RE: Tin Can Alley
6100 Alameda NE
Grading and Drainage Plan
Engineer's Stamp Date: 02/20/19
Hydrology File: C18D086

Based upon the information provided in your submittal received 02/20/2019, the Grading and Drainage Plan **is not** approved for Building Permit and Foundation Permit. The following comments need to be addressed for approval of the above referenced project:

**RE: Alameda Development
6100 Alameda NE
Conceptual Grading and Drainage Plan
Engineer's Stamp Date: 09/12/18
Hydrology File: C18D086**

Project: **Alameda & San Pedro Mixed Use Development**
6100 Alameda NE
Albuquerque, New Mexico

date:
2-20-19
sheet:
c201

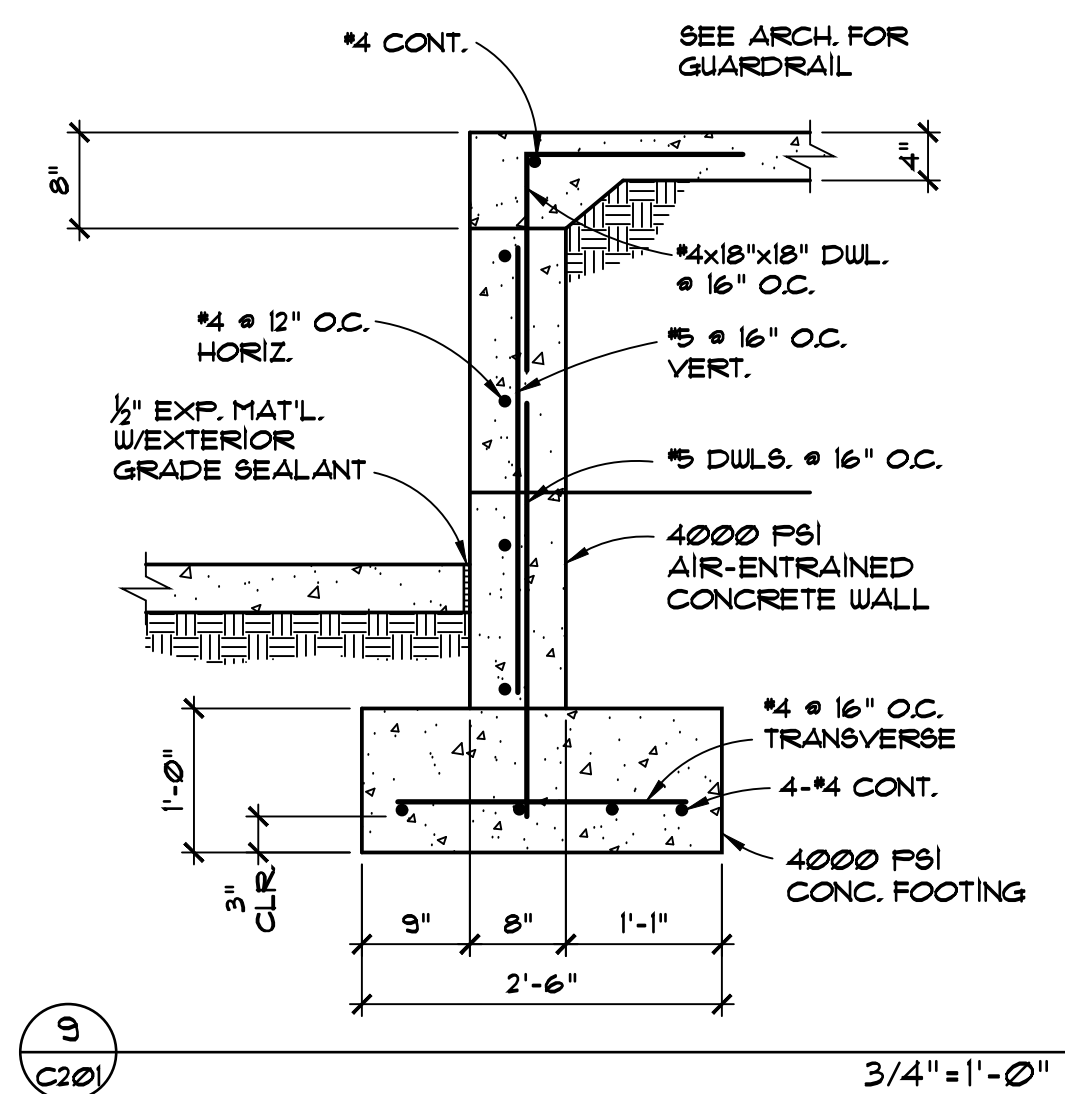
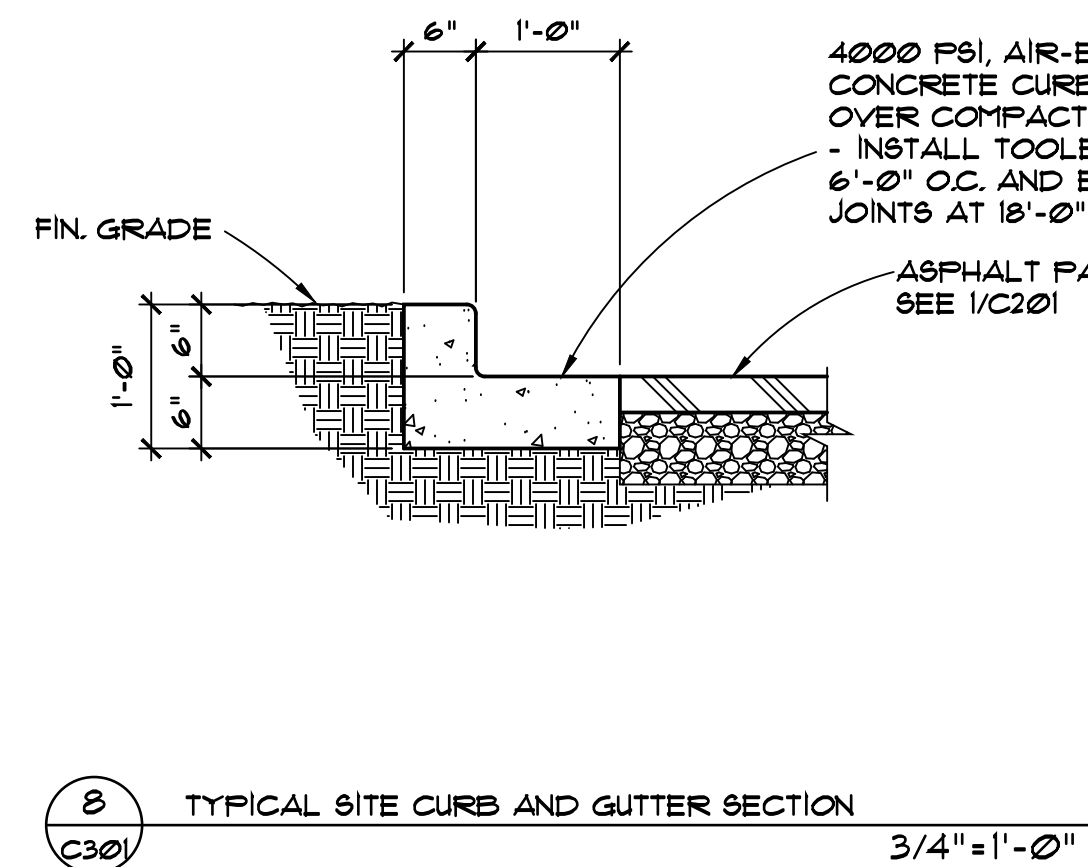
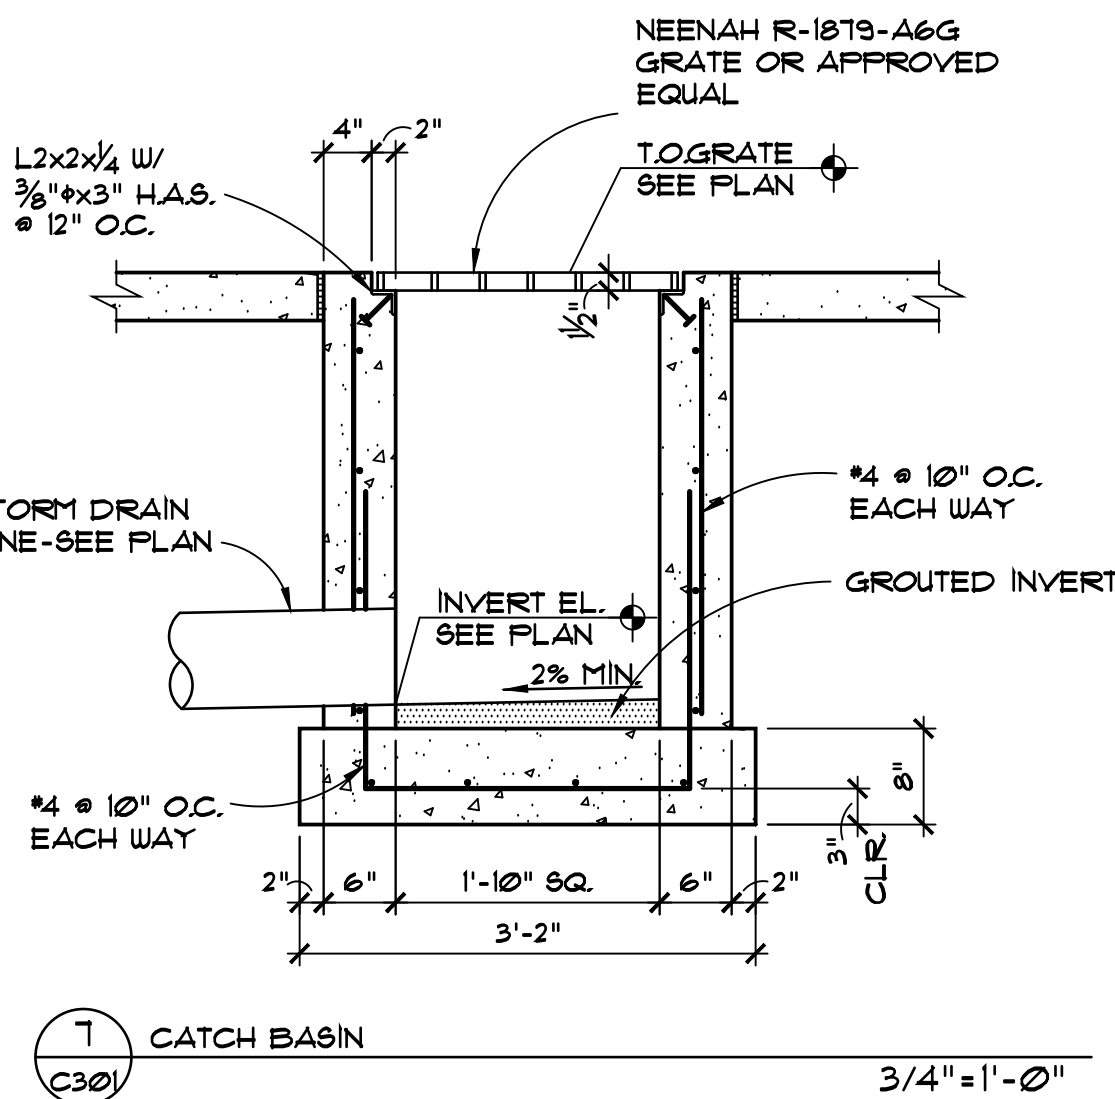
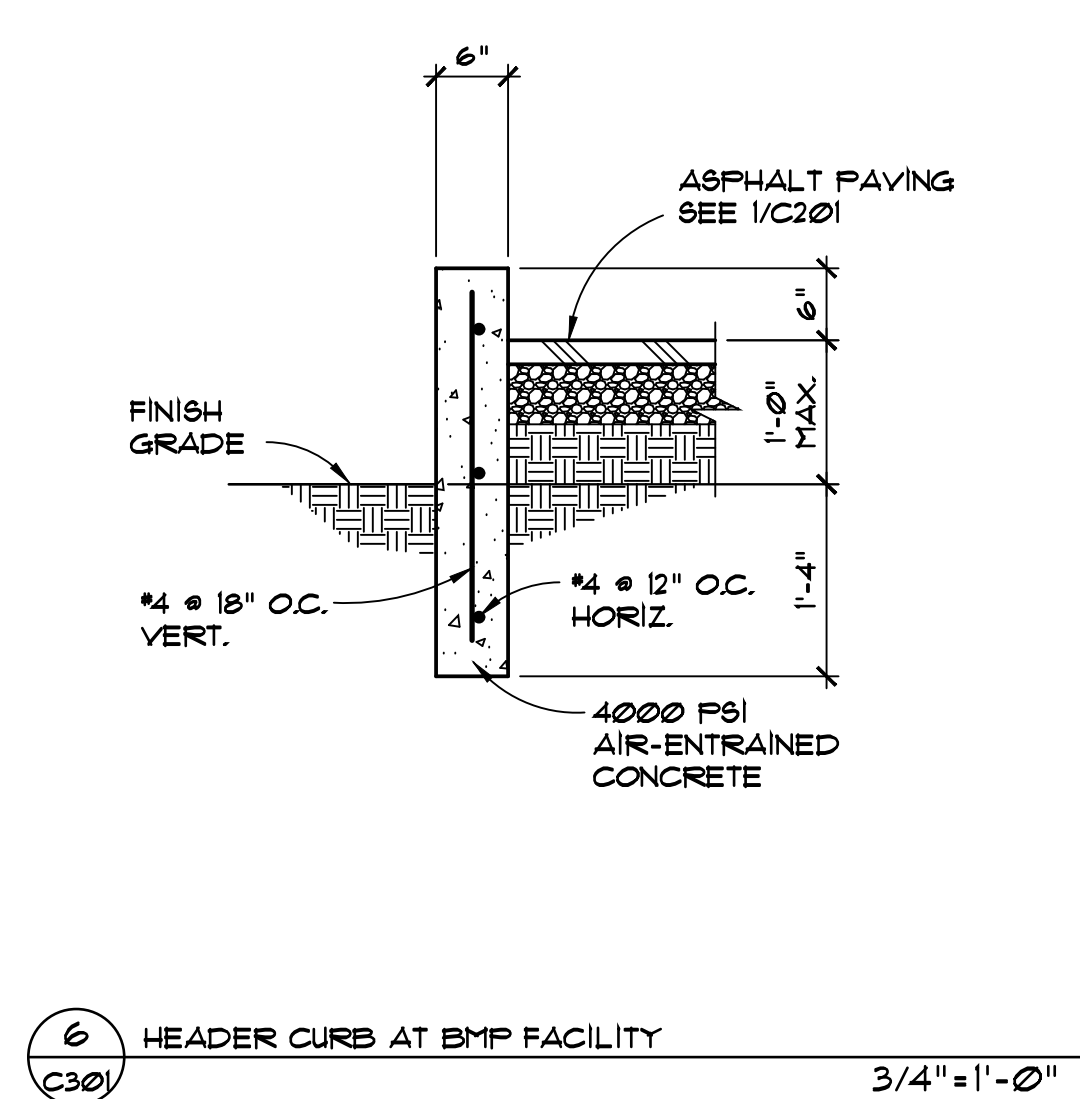
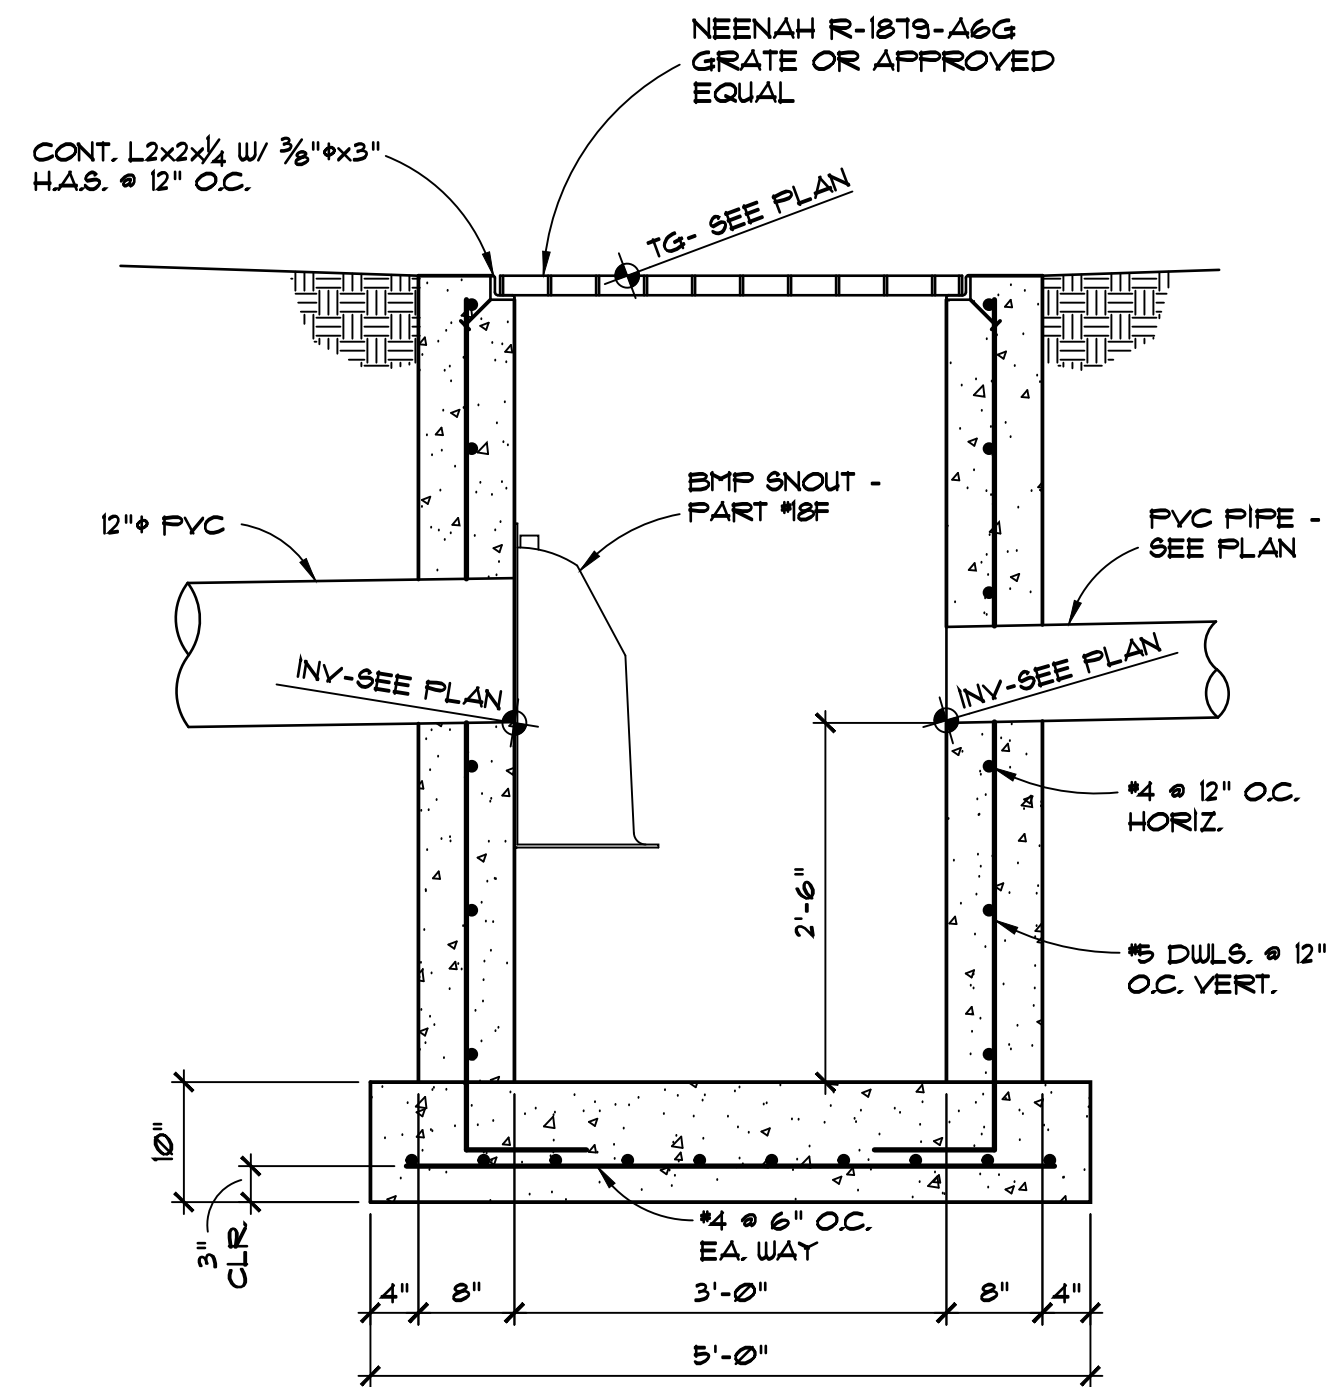
6. Where is the oil/water separator from Detail #5 from Sheet C201? If this was to be used in the dumpster area, please see Comment #5 and remove this as it is not appropriate use in a dumpster area.
